**Arlington High School Building Committee
Finance Subcommittee Meeting
Thursday, August 10, 2023
Conducted by Remote Participation
4:00 PM – 4:30 PM
Agenda**

8/10/2023 AHSBC Finance Subcommittee Meeting
Meeting Materials

Change Order (CO)

ASI 292.1

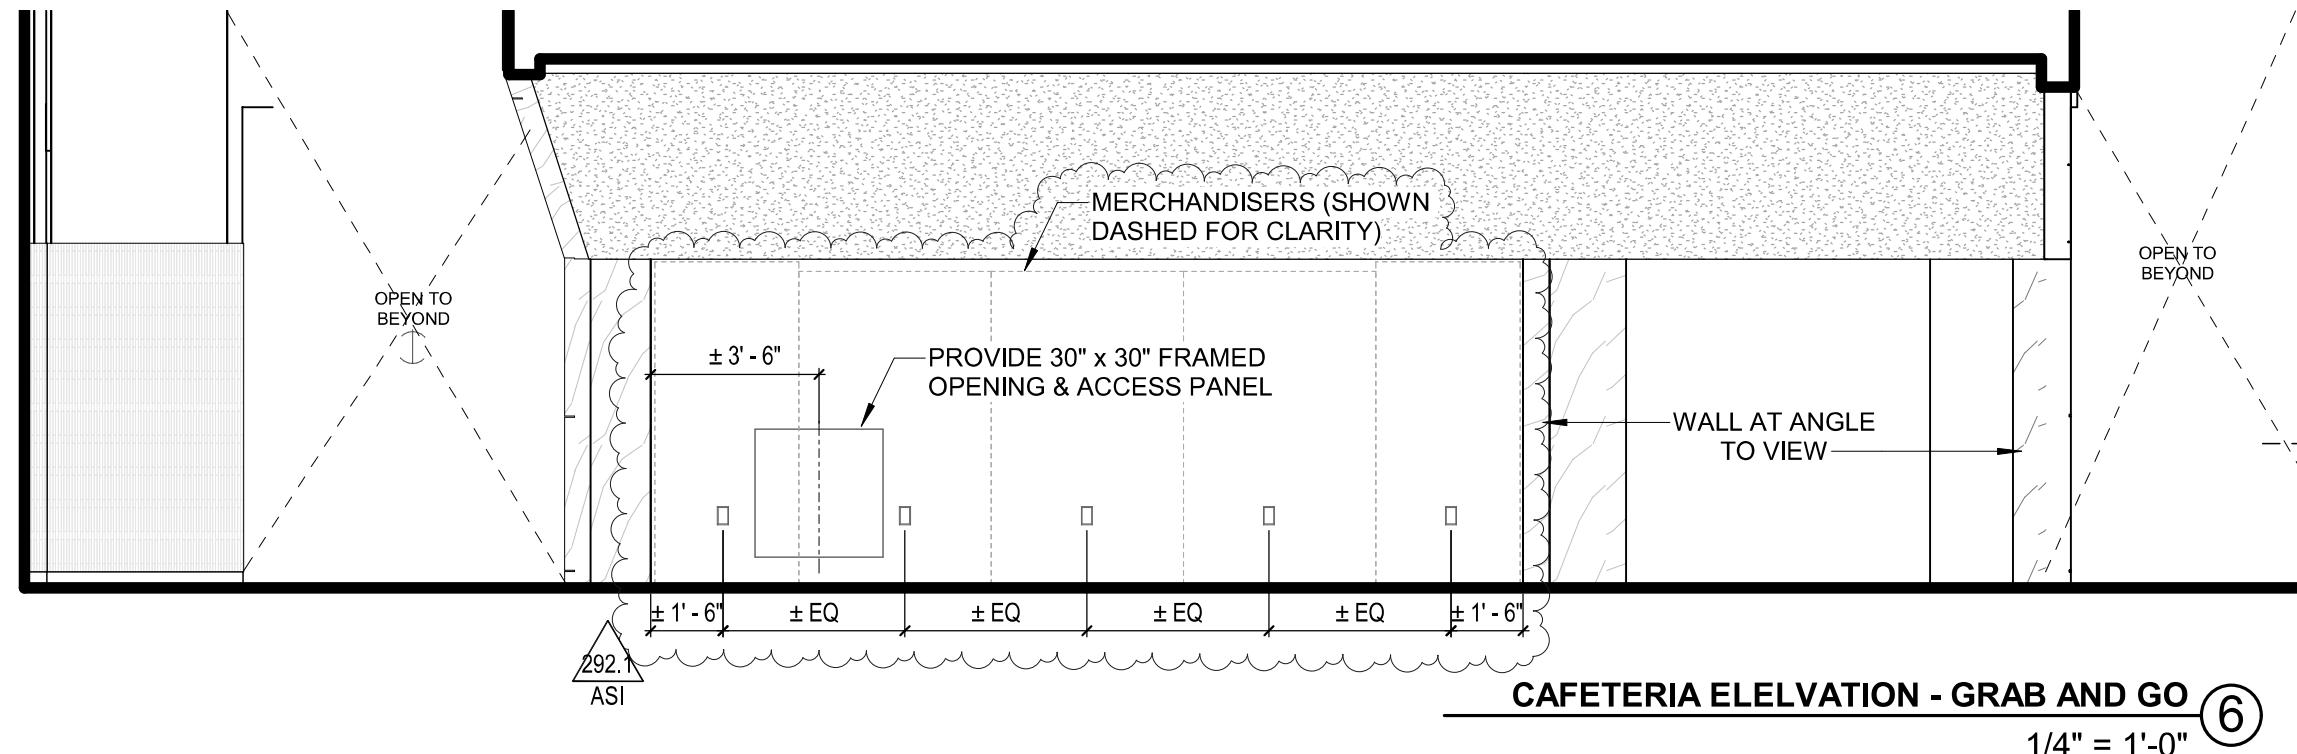
Items included in this Change Order:	Cost:
CR 619 ASI-292.1 Provide Access Panel under Forum for Owner's Time Capsule access.	\$ 797.21
CR 629R1 ASI-353 Extended length of loading dock drive retaining wall to address CVS existing retaining concern for being compromised by it's shallow footing.	\$ 98,748.76
CR 638 ASI-363 Play Area Communication Bd revised product design.	\$ 2,997.26
CR 649 PR-024 Provide markerboards for Compass Group Rm 500A.	\$ 2,168.19
CR 652 RFI-804 Provide plumbing piping for sink in OT P.212	\$ 10,543.11

attachments: Sketches SKC-048a, 048b. SKL-015

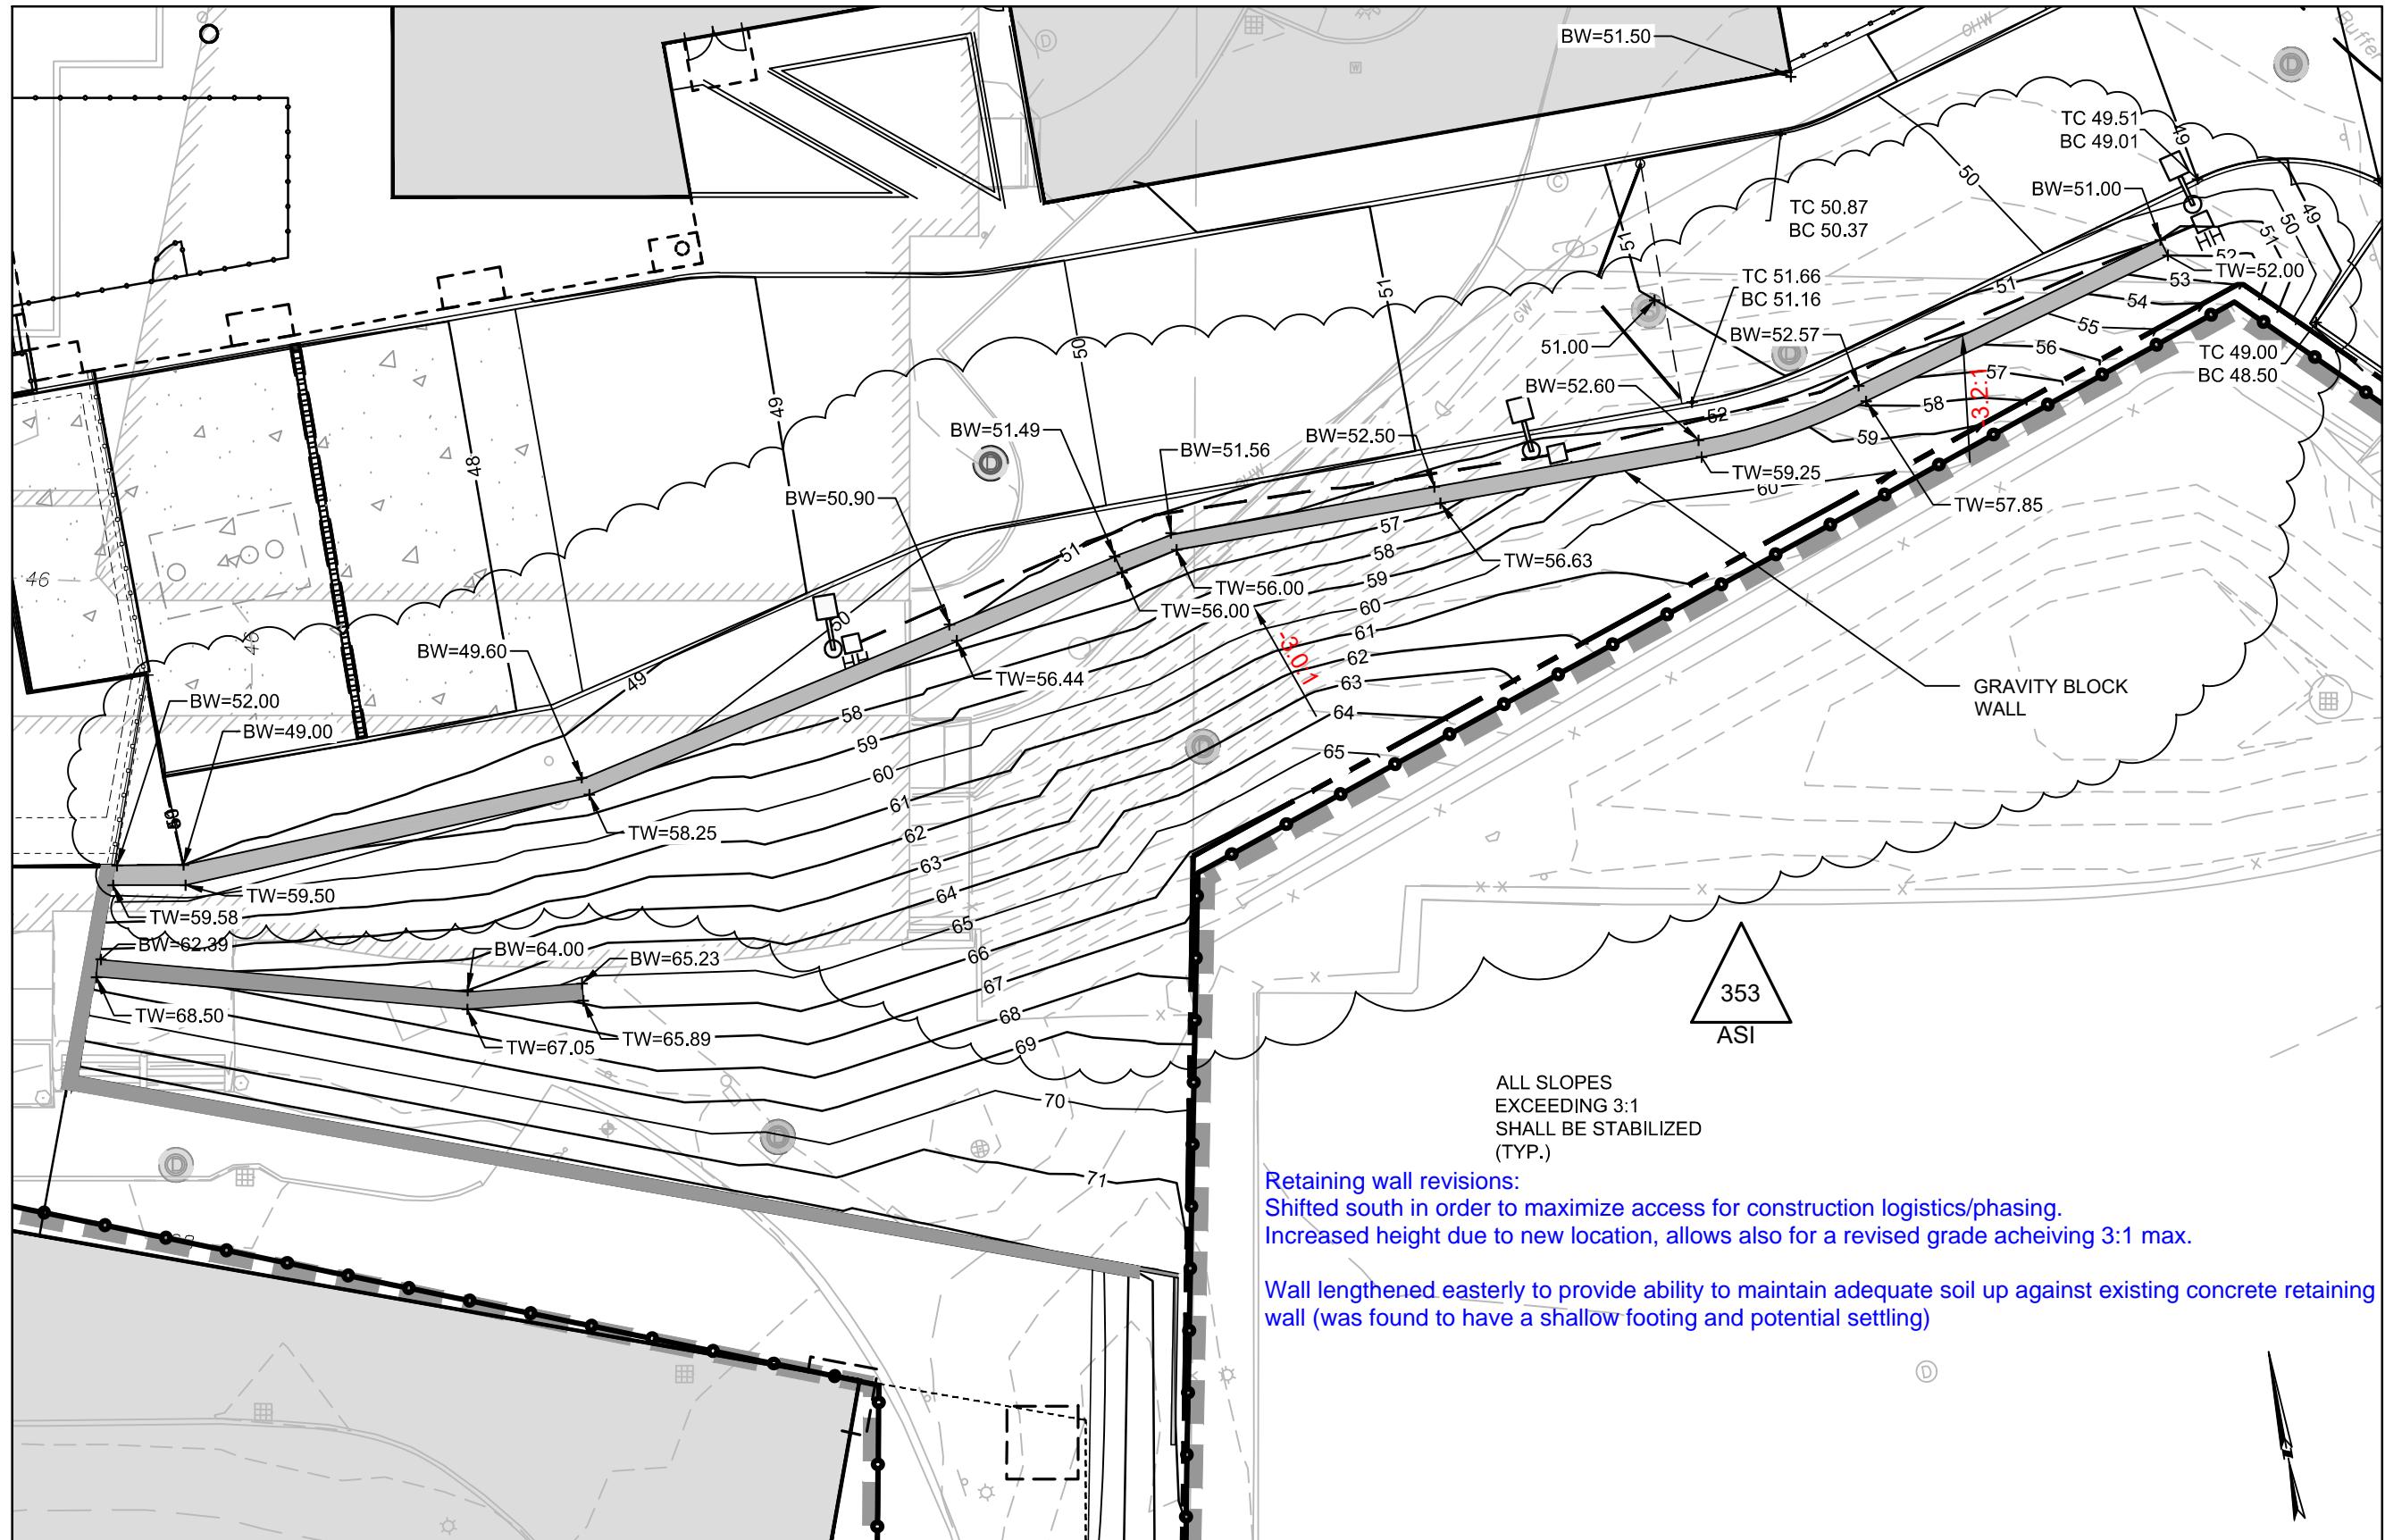
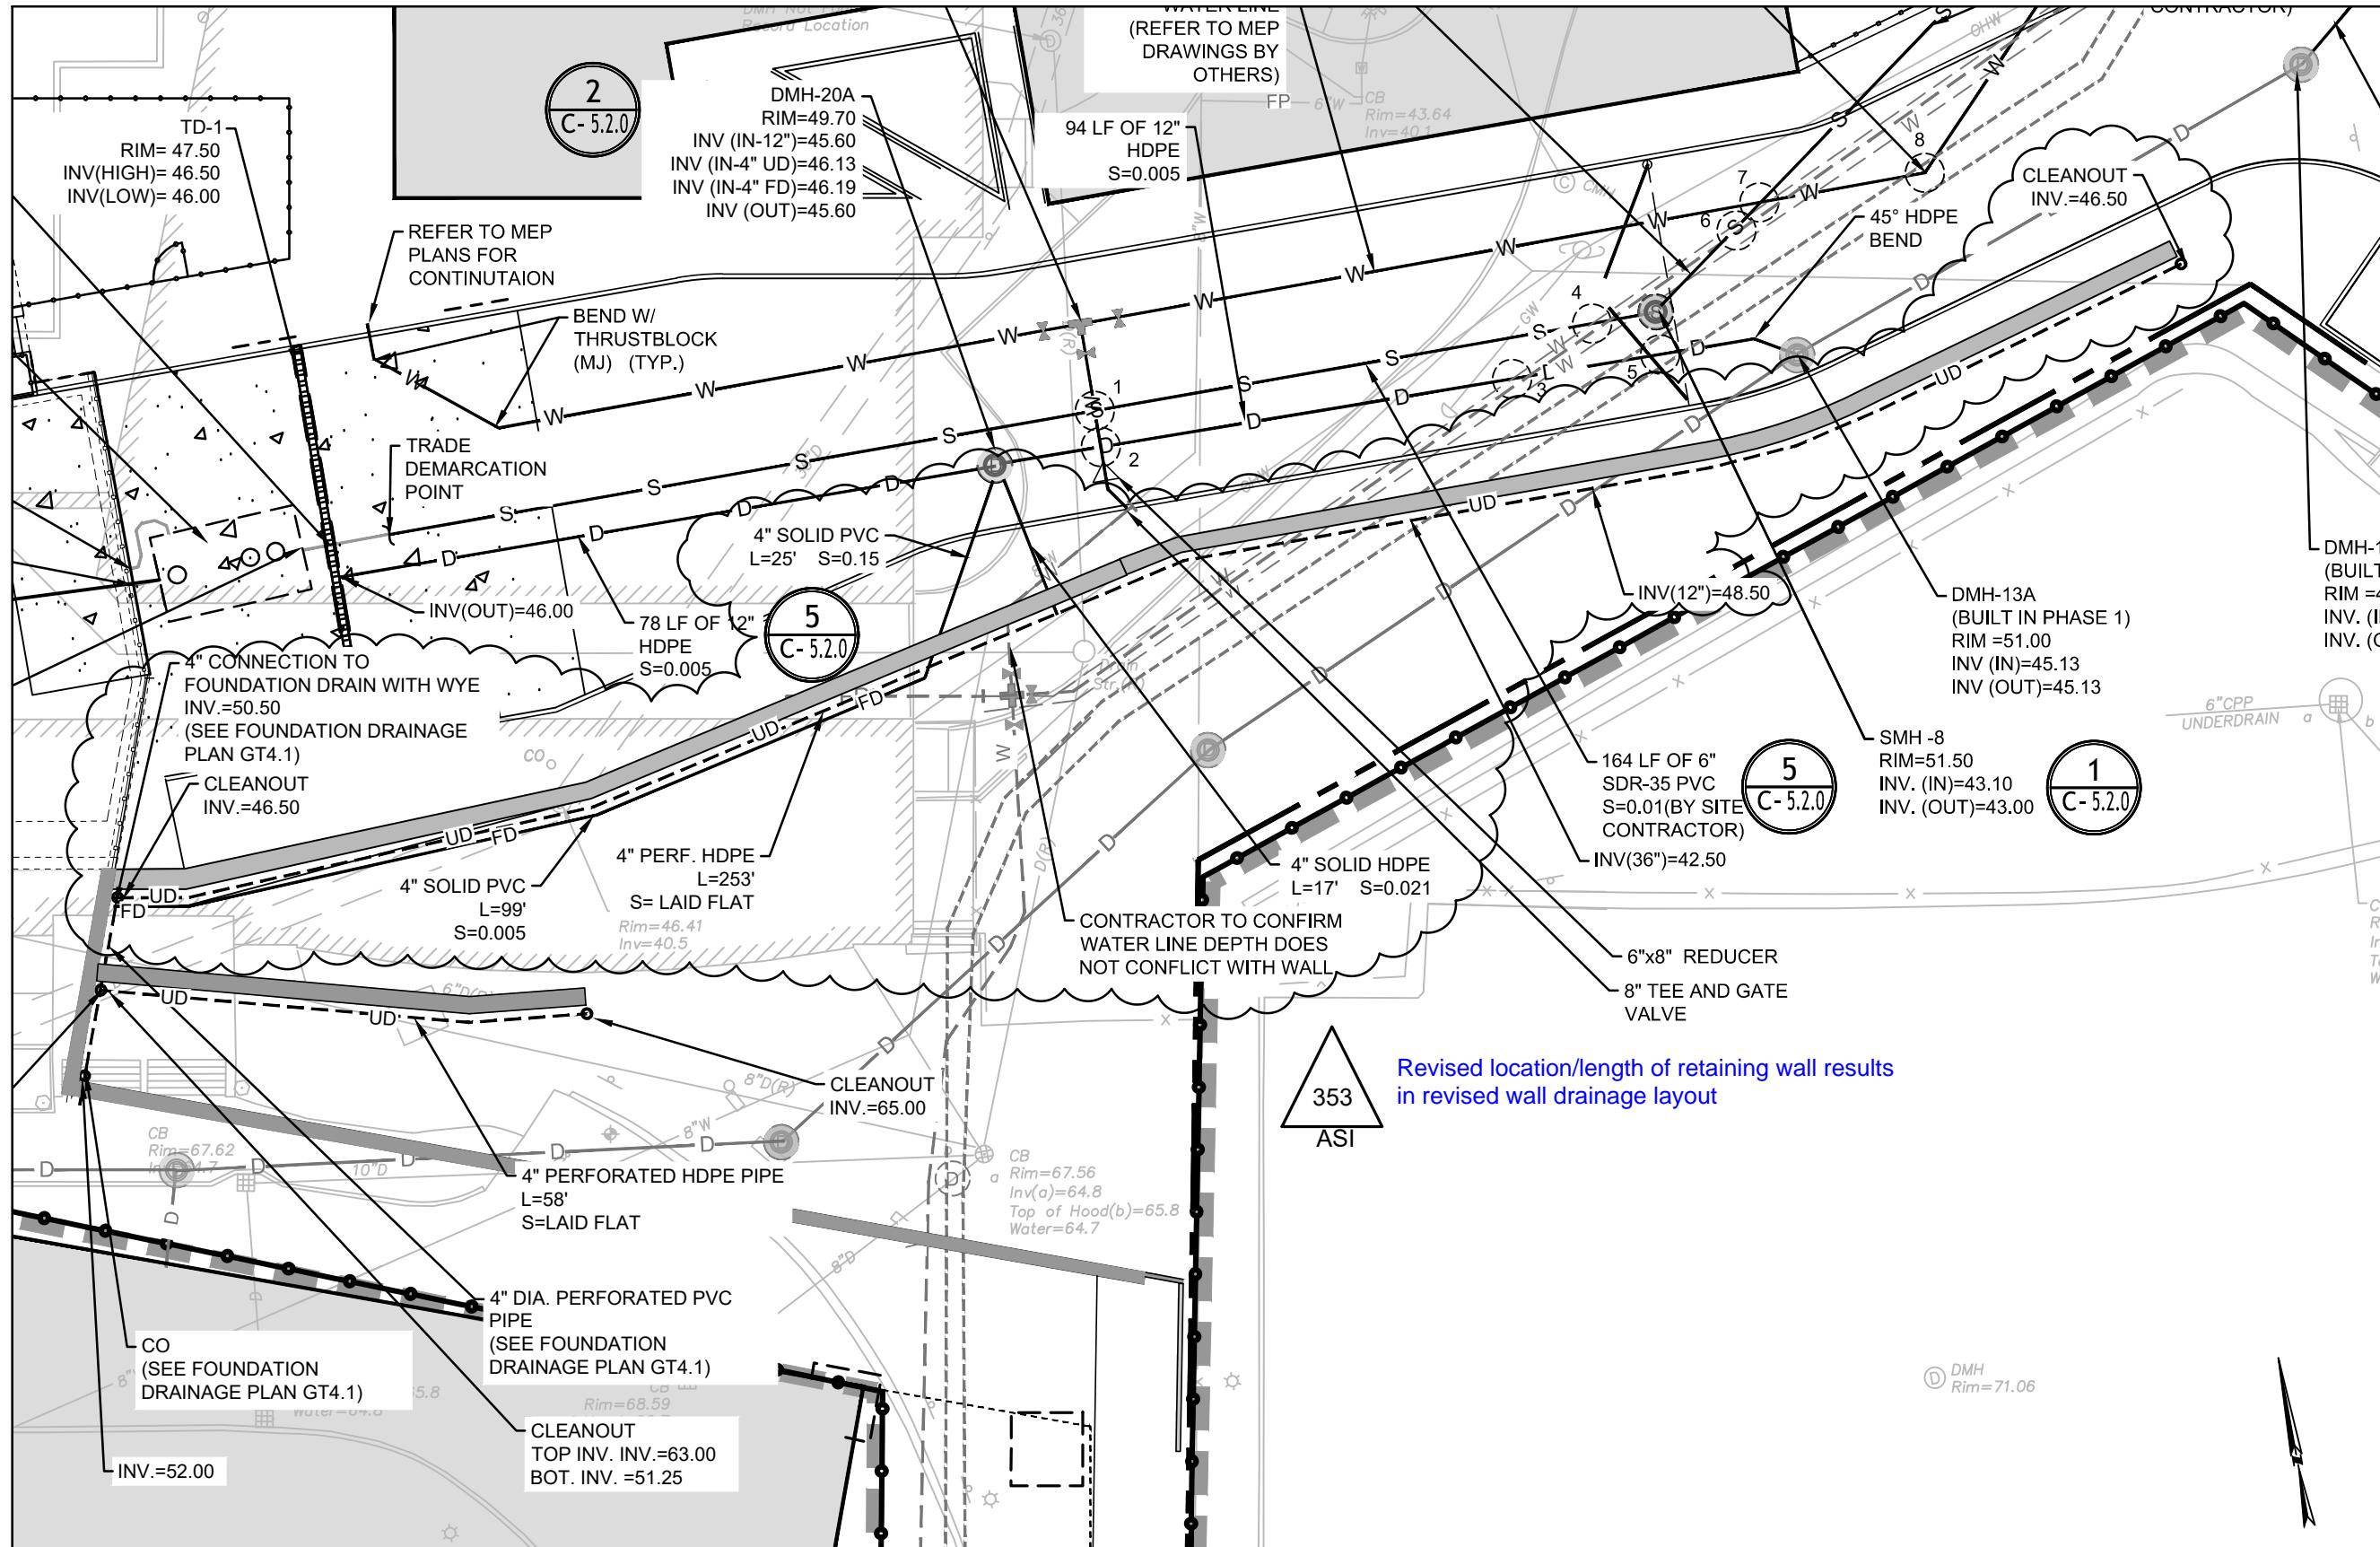
Revision to block retaining wall along (location, height and length) loading dock drive.

Shifted south to provide a wider access area during construction to improve logistics and phasing considerations. Also allows for an improved grading condition on the south side of the wall to better minimize slopes exceeding 3:1 slope and thus allows an improved tree planting condition.
